Product Change Notification

Subject	Change of the paper reel to plastic reel for aluminum electrolytic capacitors of surface-mount type (type V)
Part number	The change applies to all aluminum electrolytic capacitors of V type, including those made in both Japan and Malaysia. Except, the following series are already packaged by plastic reels; FT, TQ, FKS, TC, TCU, ZA, ZC, ZK, and ZE series
Estimated changing date	The change will start for the products to be shipped on September 1st of 2017.
Revised category	< >Design < >Parts / Materials < >Inspection / Test < # >Others
Contents	<p>Purposes of the reel change are;</p> <ol style="list-style-type: none"> 1. increasing demand for plastic reels especially in automotive industry, 2. increasing demand for plastic reels in surface-mount type capacitors, and 3. to prevent dust coming out from paper reels. <div style="display: flex; justify-content: space-around; align-items: center; text-align: center;"> <div style="margin-right: 20px;"> <p>[Current paper reel]</p>  </div> <div style="font-size: 2em; margin: 0 20px;">➔</div> <div style="margin-left: 20px;"> <p>[New plastic reel]</p>  </div> </div> <p>- Product number: P/N will be the same

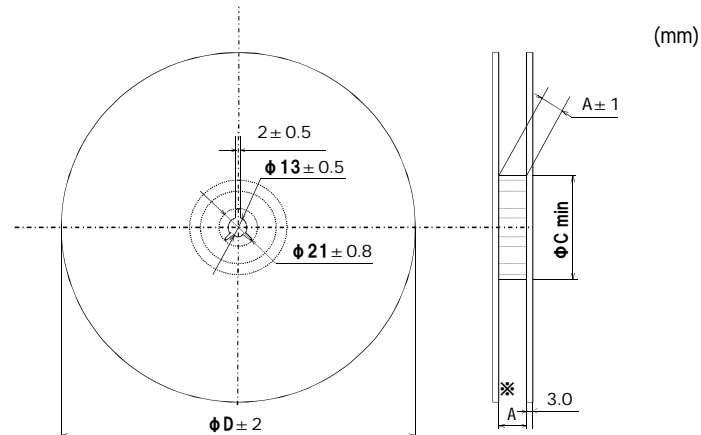
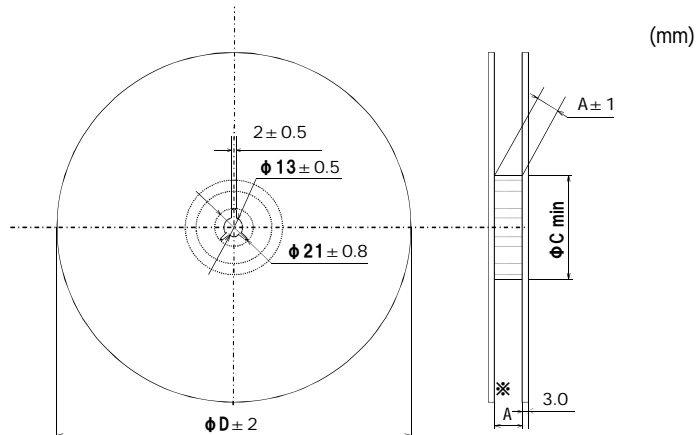
From 2017/9/1 prodcution
All P/N change material from paper to Plastic.
P/N suffix is not changed.
